Rule Changes from the Executive

Issue #2016-6 Published 12-7-16

Rule N12.5.5 Rotax Max Dellorto VHSB 34 XS (EVO) Carburettor

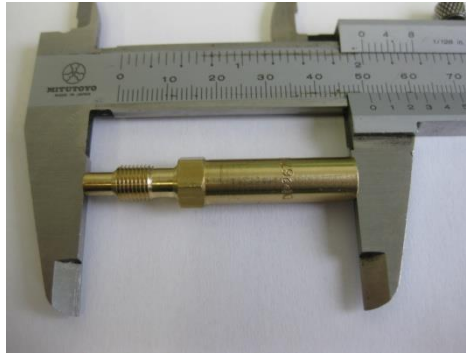
- N12.5.5 Specific specifications for Dellorto VHSB 34 XS (EVO)**
NOTE: All other items not noted are as per Dellorto VHSB 34 QS and QD specifications.
- N12.5.5.1 Slide:** must show with size "45" in casting.
- N12.5.5.2 Jet Needle:** stamped with "K57" only.
- N12.5.4.3 Floats:** Only floats marked "4.0 gr" are legal to be used.
- N12.5.4.5 deleted**
- N12.5.4.6 deleted**

N12.5.4.7

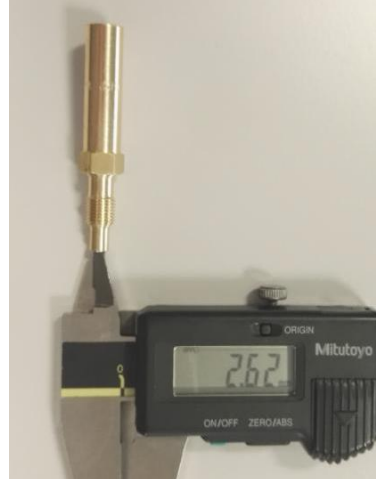
Needle Jet: stamped with "DP267".

Total length: 51.00 +/- 0.5 mm.

Length of bottom section: 33.0 +/- 0.45 mm

Top bore diameter 2.67 +/- 0.10 mm

N12.5.4.10 **Atomizer:** Remove atomizer from carburettor body by means of a venturi tool set.

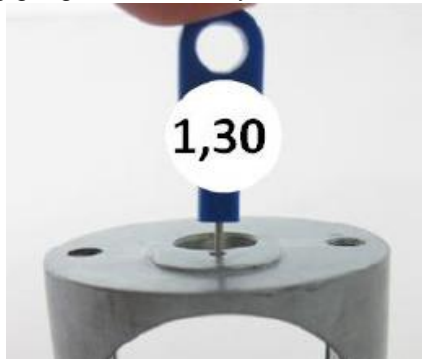
Total length: 23.75 +/- 0.35 mm

Atomizer length of cylindrical part: 15.75 +/- 0.25 mm

Atomizer dimension of cutaway: 5.8 +/- 0.3 mm

Atomizer dimension of cross bore: 5.0 +/- 0.15 mm

Rule N14.5.5 Rotax Junior Max Dellorto VHSB 34 XS (EVO) Carburettor
Replace the current Rules with the following:

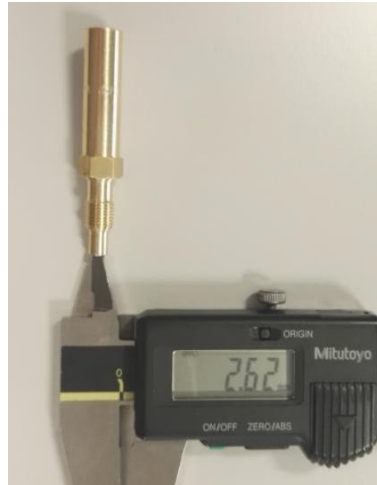
- N14.5.5 Specific specifications for Dellorto VHSB 34 XS (EVO)**
NOTE: All other items not noted are as per Dellorto VHSB 34 QS and QD specifications.
- N14.5.5.1 Slide:** must show with size "45" in casting.
- N14.5.5.2 Jet Needle:** stamped with "K57" only.
- N14.5.4.3 Floats:** Only floats marked "4.0 gr" are legal to be used.
- N14.5.4.5 deleted**
- N14.5.4.6 deleted**
- N14.5.4.7 Needle Jet:** stamped with "DP267".
Total length: 51.00 +/- 0.5 mm.

Length of bottom section: 33.0 +/- 0.45 mm

Top bore diameter 2.67 +/- 0.10 mm

N14.5.4.10 **Atomizer:** Remove atomizer from carburettor body by means of a venturi tool set.

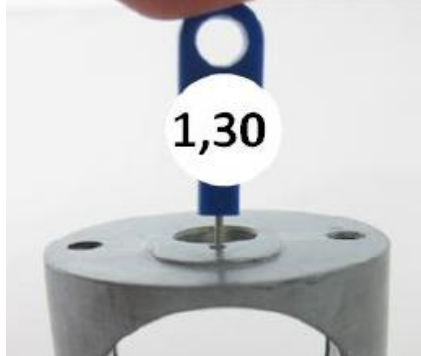
Total length: 23.75 +/- 0.35 mm

Atomizer length of cylindrical part: 15.75 +/- 0.25 mm

Atomizer dimension of cutaway: 5.8 +/- 0.3 mm

Atomizer dimension of cross bore: 5.0 +/- 0.15 mm

Rule N16.5.5 Rotax Max DD2 Dellorto VHSB 34 XS (EVO) Carburettor
Replace the current Rules with the following:

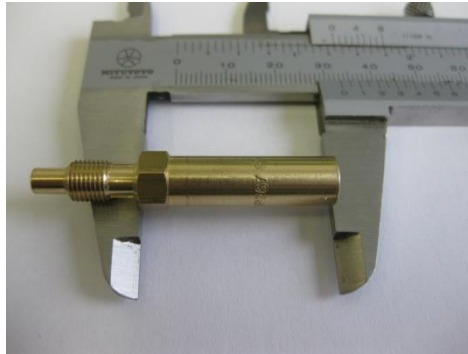
- N16.5.5** **Specific specifications for Dellorto VHSB 34 XS (EVO)**
NOTE: All other items not noted are as per Dellorto VHSB 34 QS and QD specifications.
- N16.5.5.1** **Slide:** must show with size "45" in casting.
- N16.5.5.2** **Jet Needle:** stamped with "K57" only.
- N16.5.4.3** **Floats:** Only floats marked "4.0 gr" are legal to be used.
- N16.5.4.5** **deleted**
- N16.5.4.6** **deleted**
- N16.5.4.7** **Needle Jet:** stamped with "DP267".
Total length: 51.00 +/- 0.5 mm.

N16.5.4.10 **Atomizer:** Remove atomizer from carburettor body by means of a venturi tool set.

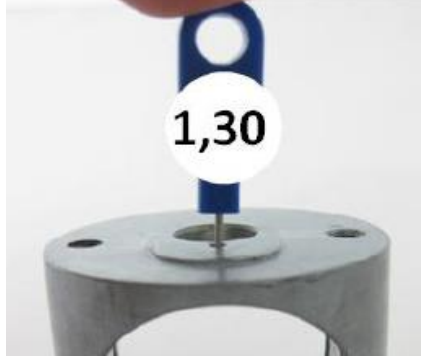
Total length: 23.75 +/- 0.35 mm

Atomizer length of cylindrical part: 15.75 +/- 0.25 mm

Atomizer dimension of cutaway: 5.8 +/- 0.3 mm

Atomizer dimension of cross bore: 5.0 +/- 0.15 mm
